Access Compliance Report

Public Rights-of-Way

Intersection ID: 47363	Main Street: JORDAN_PL	Cross Street: MATHESON_AV	Location: S
ADA ID: 35C27DDA21C4	Ramp Type: BlendTrans1	Initial Pass/Fail: Fail	Overall Compliance: No
		Severity Score: 8.75

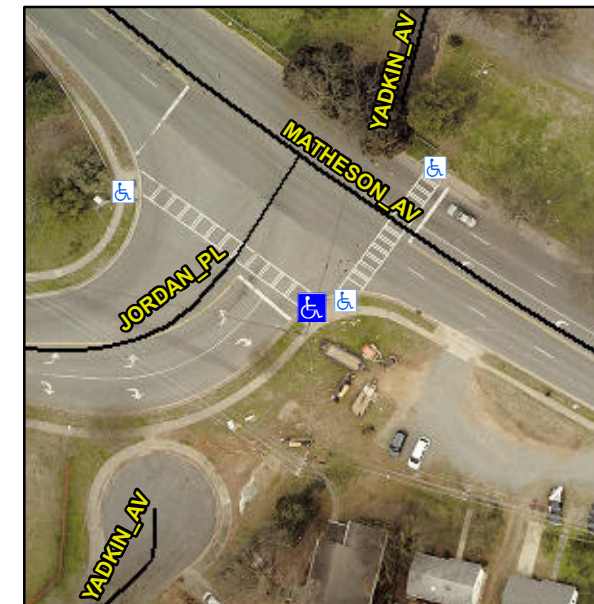
Not Found, R304.5.1

Compliance	Description	Data	Compliance	Description	Data
N/A	Ramp Length (in)	71.0	Yes	BlendTrans Slope (%)	3.7
No	Ramp Width (in)	42.5	Yes	BlendTrans XSlope (%)	1.2
N/A	Flare Type LT	N/A	N/A	Flare Type RT	N/A
N/A	Flare Slope LT (%)	N/A	N/A	Flare Slope RT (%)	N/A
N/A	Flare Traversable LT?	N/A	N/A	Flare Traversable RT?	N/A
N/A	Landing Length (in)	N/A	N/A	DWS Provided?	N/A
N/A	Landing Width (in)	N/A	N/A	DWS Contrast?	N/A
N/A	Landing Slope (%)	N/A	N/A	DWS Length (in)	N/A
N/A	Landing X Slope (%)	N/A	N/A	DWS Full Width?	N/A
N/A	Landing Curb? (Y/N)	N/A	N/A	DWS Offset (in)	N/A
N/A	Shared Landing?	N/A			
N/A	Gutter Ponding?	N/A	N/A	Gutter Slope (%)	N/A
N/A	Gutter Lip Ht (in)	N/A	N/A	Gutter X Slope (%)	N/A
N/A	Painted X Walk1?	Yes	N/A	Painted X Walk2?	N/A
	X Walk 1 Direction	To NW		X Walk 2 Direction	N/A
	X Walk 1 Width (in)	104.5		X Walk 2 Width (in)	N/A
	X Walk 1 Slope (%)	0.1		X Walk 2 Slope (%)	N/A
	X Walk 1 X Slope (%)	0.7		X Walk 2 X Slope (%)	N/A

N/A	Ramp inside XWalk1?	Yes	N/A	Ramp inside XWalk2?	N/A
	Road Slope (%)	0.7		Clear Space?	N/A
	Road X Slope (%)	0.1	N/A	Clear Space to XWalk (in)	N/A
N/A	Any Obstructions?	N/A	N/A	Storm Grate/Utility Hazard?	N/A
	Obstruction Type			Storm Grate/Utility Type	
		N/A			N/A
			Yes	Surface Condition? (G/P)	Good
			No	Curb Slope (%)	16.2

Remove & Replace Curb Ramp With Two New Directional Ramps or Equivalent.
